# POST OCCUPANCY EVALUATION

## TE KURA KAUPAPA O WHANGAROA, MATAURI BAY, NORTHLAND

**November 2015**

Date: November 2015  
Reference: 1-46083.00  
Status: Final Rev 05

Figure 1

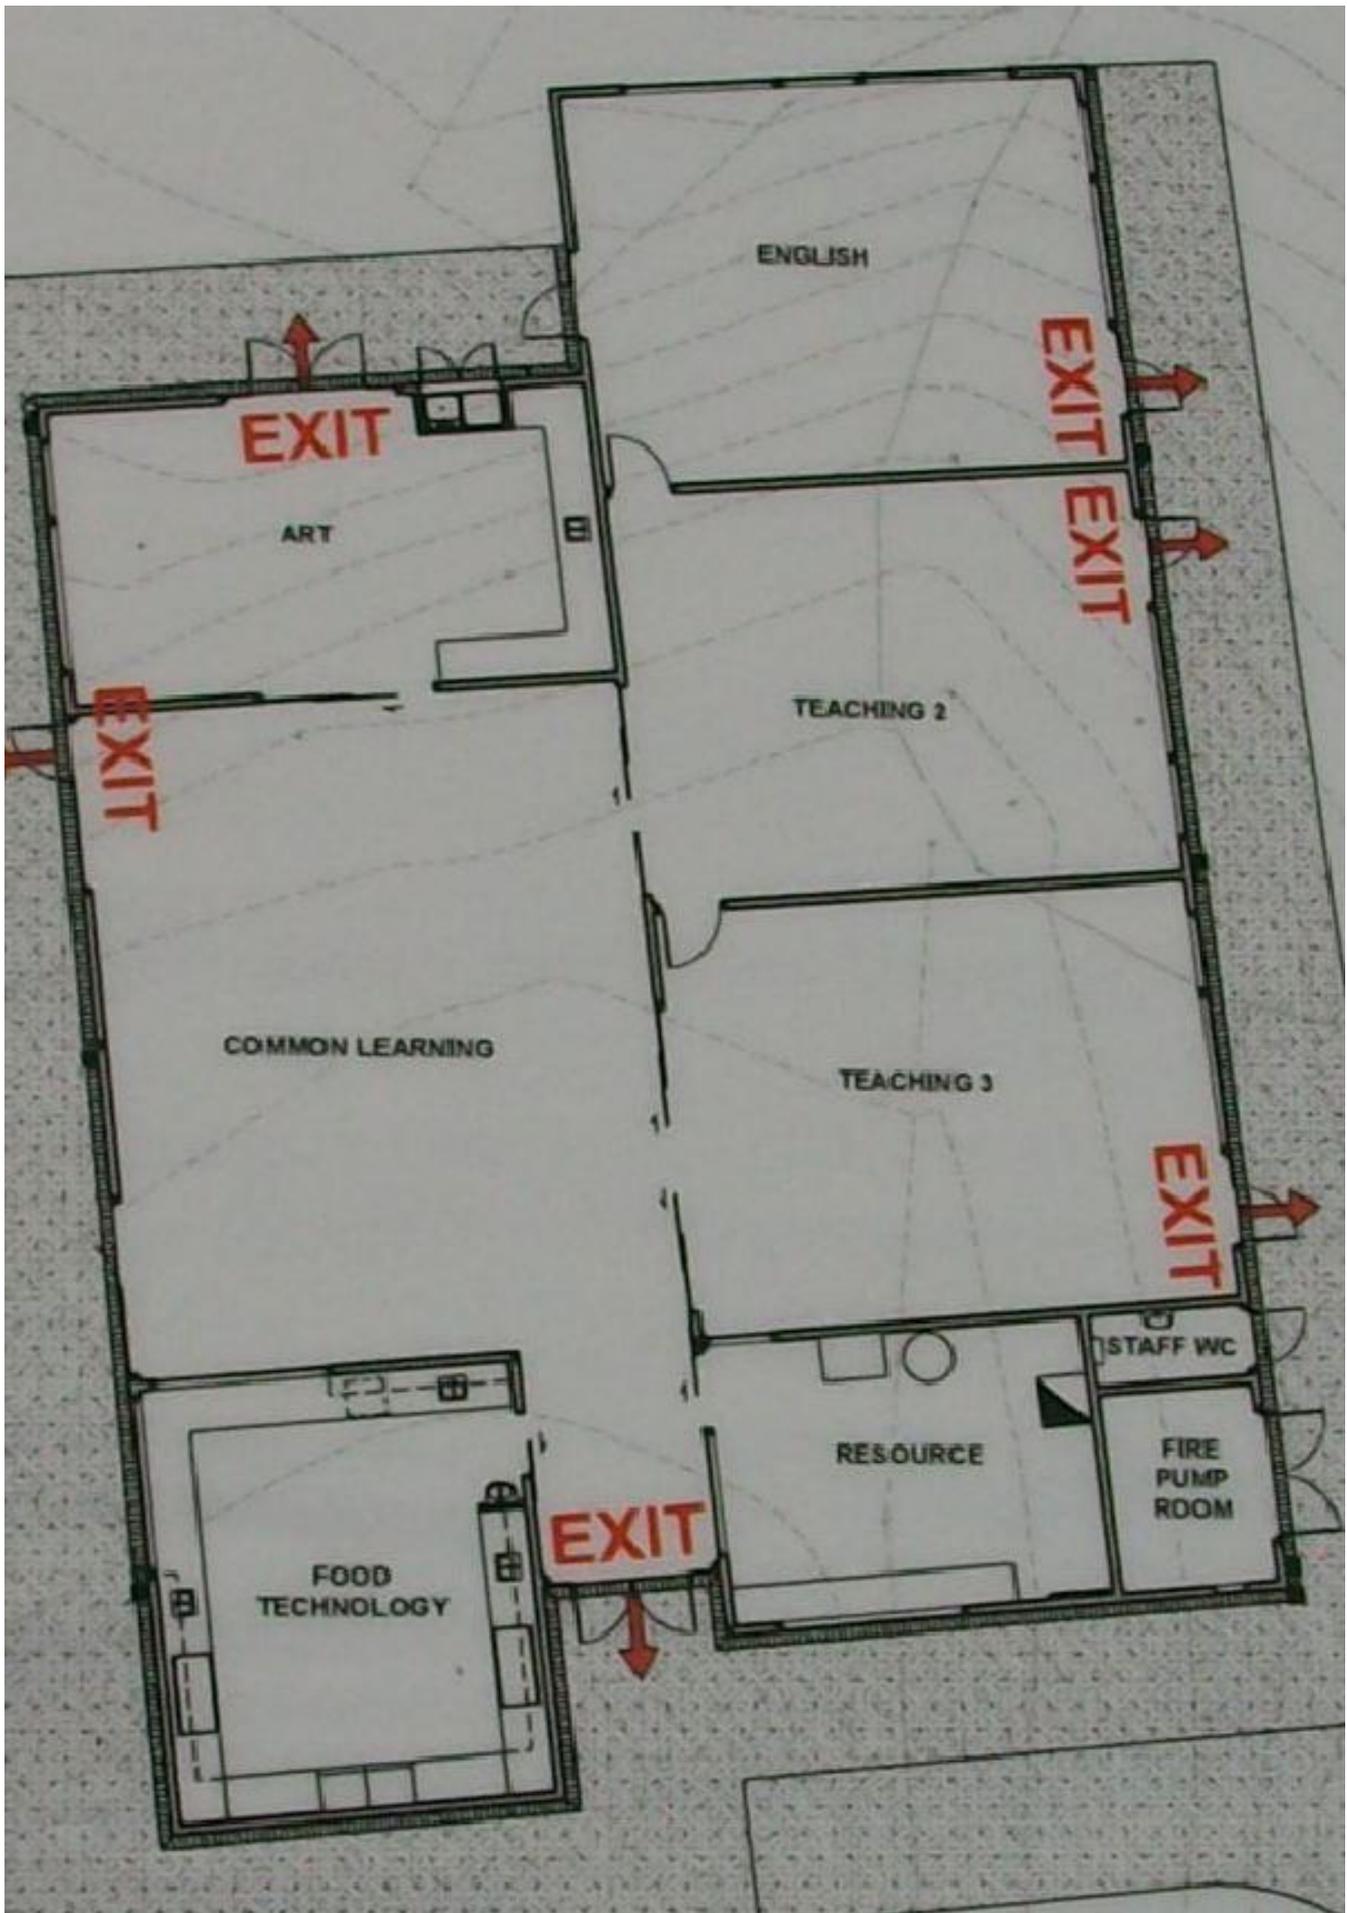
- There are no corridors within the new classroom block, thus maximising floor space use. Circulation is directly room to room through a central meeting room, maximising the use of floor space. See Figure 1.

Figure 2

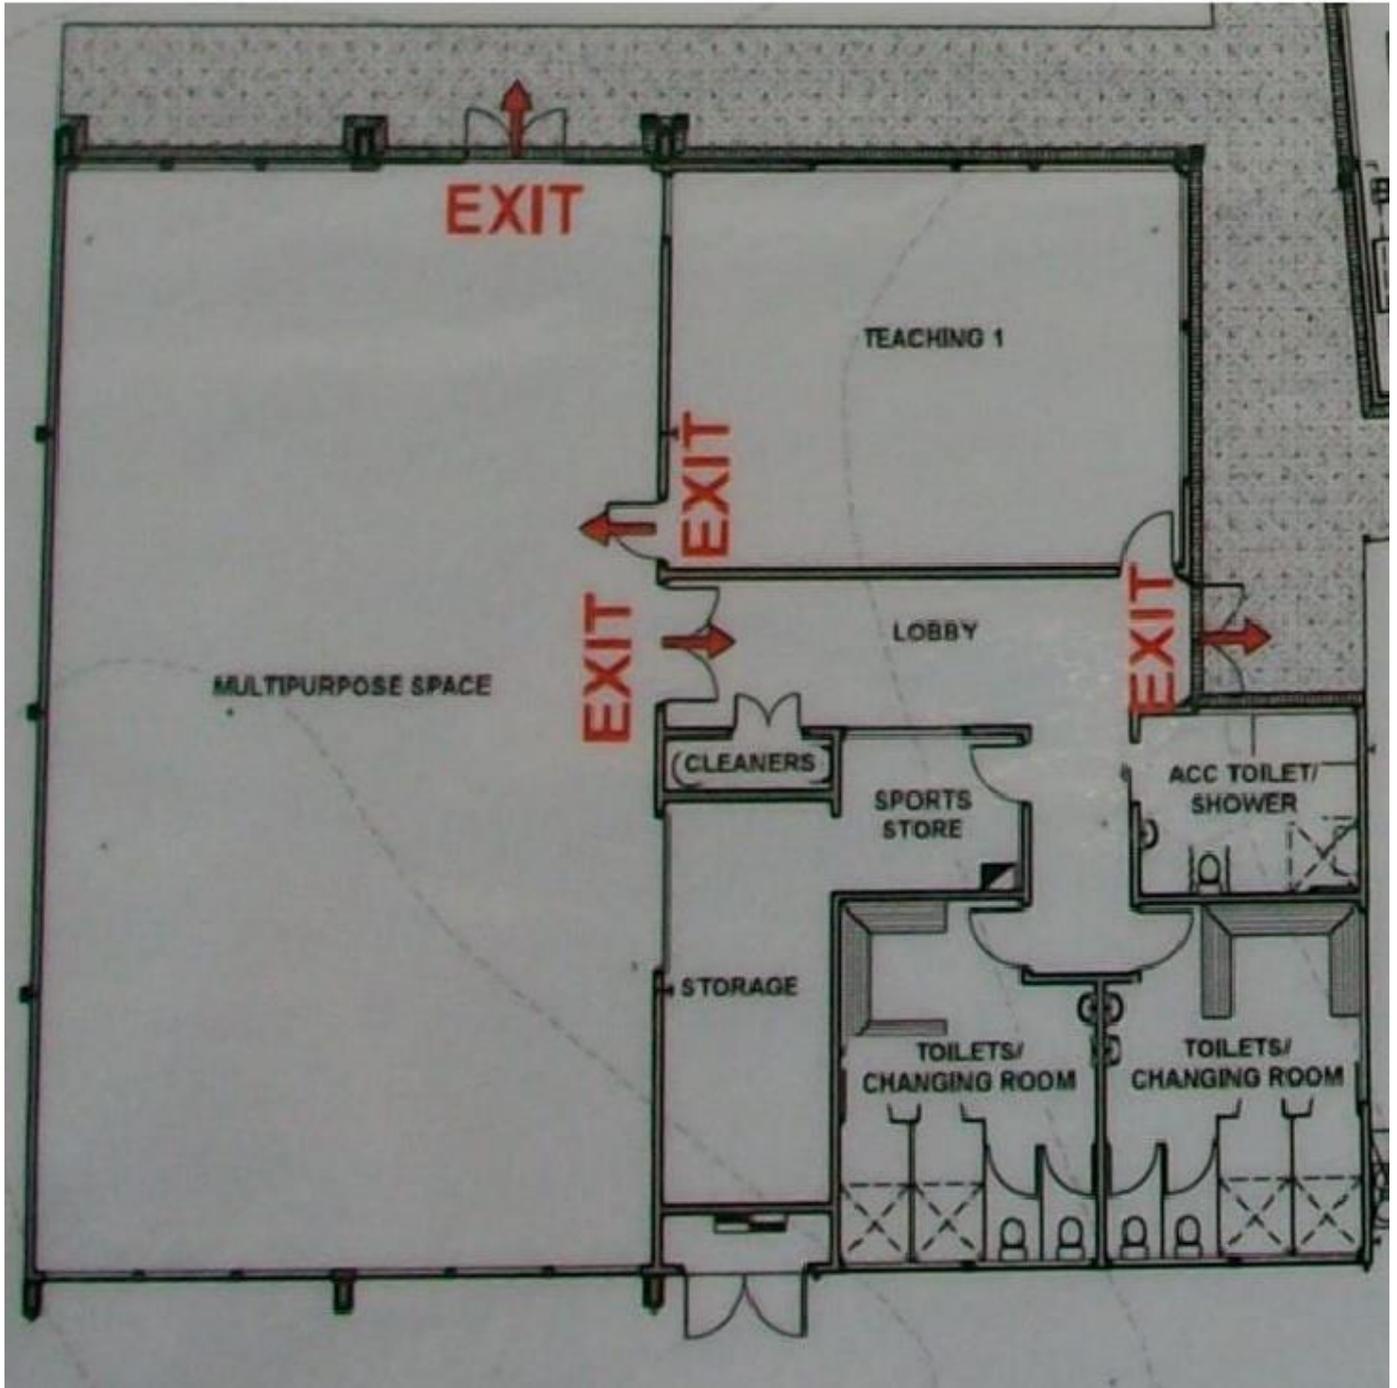
- Block 02: Gym shower rooms, the hot water only lasts long enough for one person to use the shower. Despite the large cylinders (there are two, one for toilet and showers, 1 for kitchen) that were installed there is still a capacity issue.

Review the hot water capacity issue serving the showers to block 02 changing rooms.

Figure 20

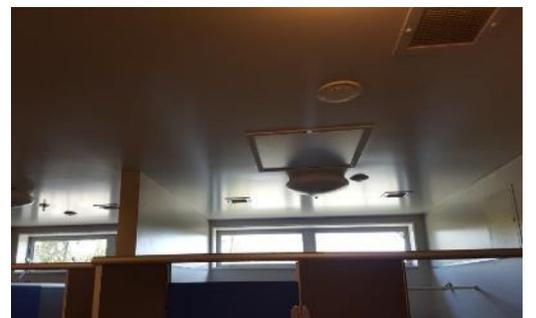
- Toilets have mechanical ventilation installed in addition to natural ventilation. The toilets are all mechanically ventilated with motion sensors/ light switch delay timers. Opening windows are also installed. See Figure 20

Figure 33

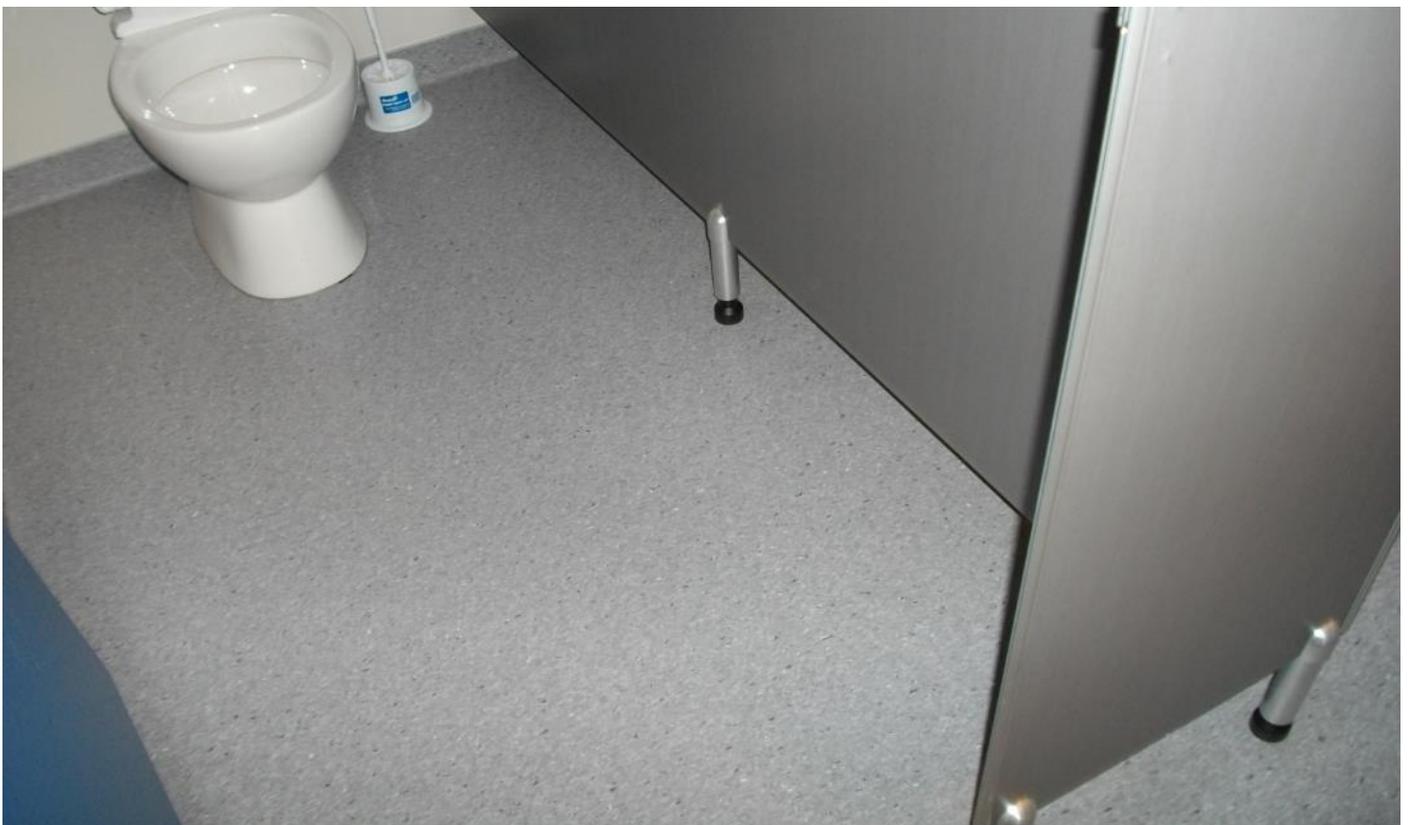
- Hot water is available where required. Heat pump type pressure hot water cylinders are installed with auxiliary heating elements. Two heat-pump type cylinders are provided in a circulating loop which should give excellent energy efficiency.
- A combination of natural and energy efficient artificial lighting systems has provided effective lighting levels for the relevant task to each area. Lighting levels were measured at about 320-400 lux in the teaching spaces with about 850-920 lux in the gym. Lighting is primarily fluorescent throughout.
- Block 02: WC/changing rooms. Very high quality, some of the best we have seen in a school development. Robust and well designed. See Figure 32 to Figure 36.
- Block 02: Changing wet areas have been designed so that they are easy to clean. Fixtures have been wall mounted to allow for easy cleaning. See Figure 33 and Figure 34.
